JACKSON HEIGHTS SUBDIVISION, FIFTH UNIT, **MARTENSTEIN ADDITION TO**

APPLICATION NUMBER 9 DATE June 3, 2010
 Jackson Heights Subdivision, Martenstein
 APPLICANT Addition to, Fifth Addition
 REQUEST Subdivision

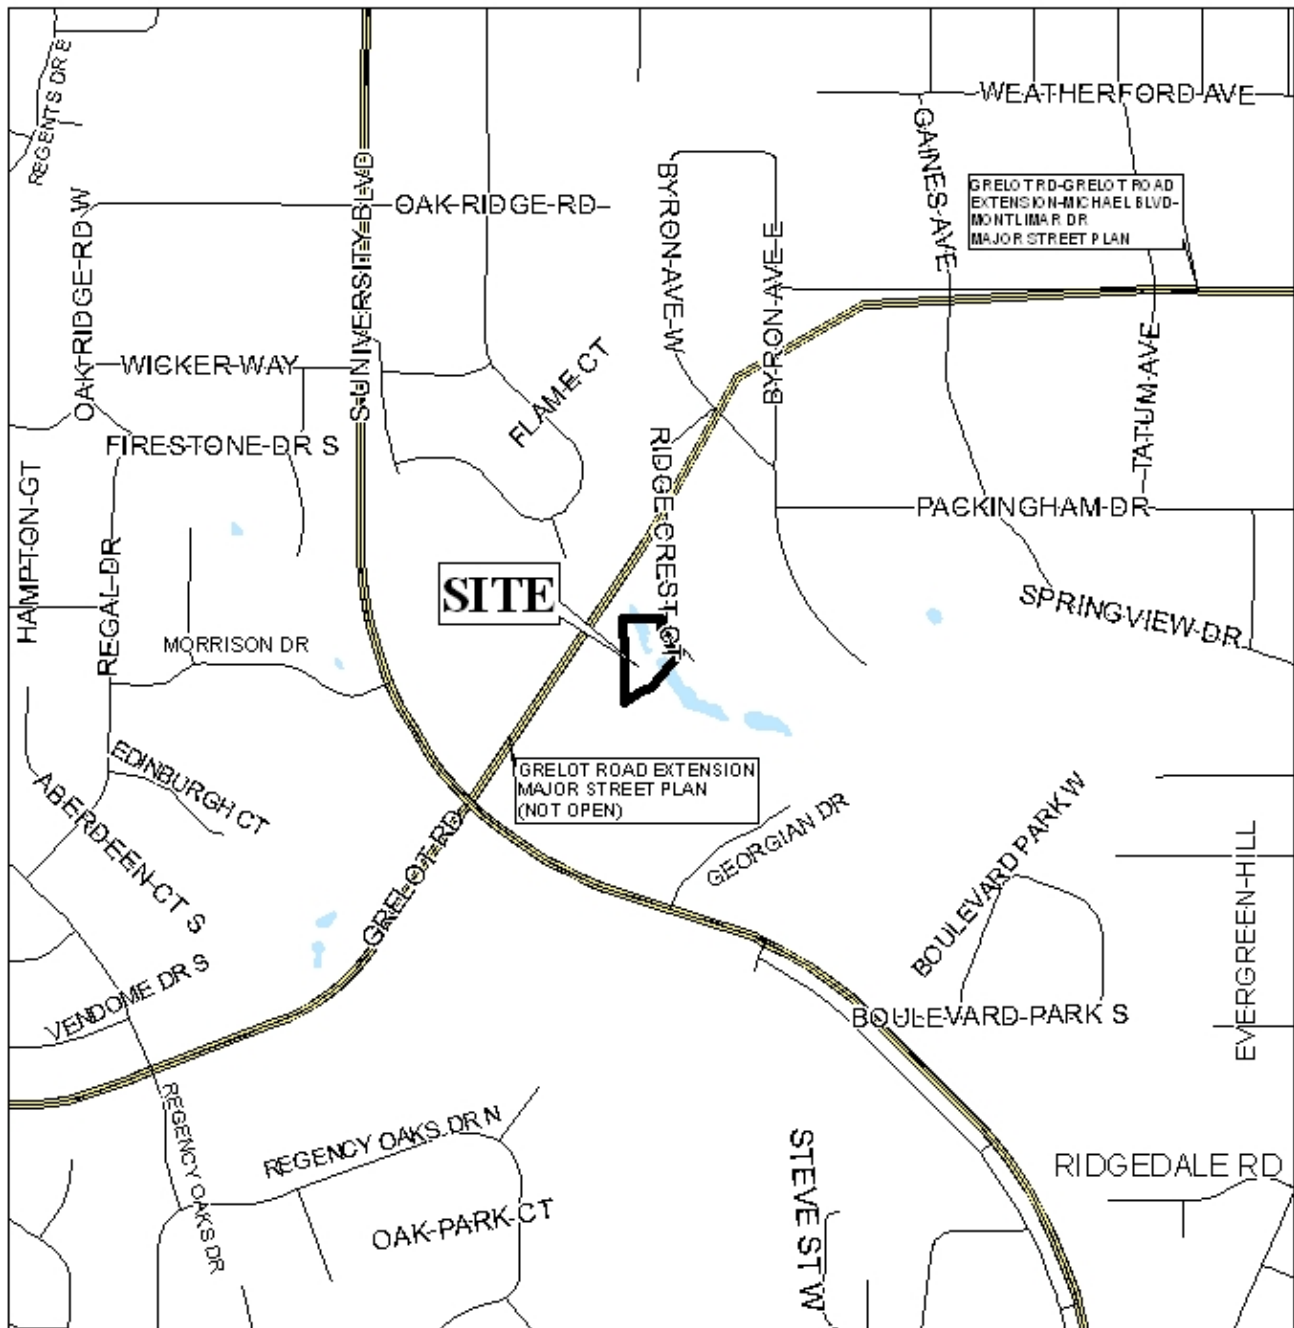
The proposed lots, as depicted, meet the minimum size and frontage requirements as regulated by the Subdivision Regulations. The lot area size is depicted on the plat, and this information should be retained on the final plat, if approved.

The 25-foot minimum building setback line is depicted on the preliminary plat, however the plat is depicting the line in lots that are not part of this subdivision, including Lot 2 of the Resubdivision of Lots 1 and 2, Resubdivision of Lot 8, Jackson Heights, 5th Unit. This lot is recorded with a minimum building line of 109 feet. As such, the minimum building line should be depicted on the Final Plat, if approved, as being only on the lots that are in this subdivision application, and labeled accordingly.

Both of the proposed lots are currently developed. This resubdivision will not cause a zoning violation. The two lots currently have one curb cut each. As such, both lots should be limited to the existing number of curb cuts, one, with the size, design, and exact location of all curb cuts to be approved by Traffic Engineering and conform to AASHTO standards.

A large portion of both of the lots appears to be located within the flood plain of Bolton Branch Creek. As depicted on FEMA Flood Insurance Rate Maps, the site contains both AE and X zones. The presence of floodplains indicates that the area may be environmentally sensitive; therefore, the approval of all applicable federal, state and local agencies would be required prior to the issuance of any permits or land disturbance activities.

- 1) modification of the 25-foot minimum building setback line on the Final Plat so that it is only depicted on the lots in this subdivision;
- 2) retention of the lot area size labeling, in square feet, on the Final Plat;

- 3) placement of a note on the Final Plat stating that each lot is limited to one curb each, with the size, design, and exact location of all curb cuts to be approved by Traffic Engineering and conform to AASHTO standards;
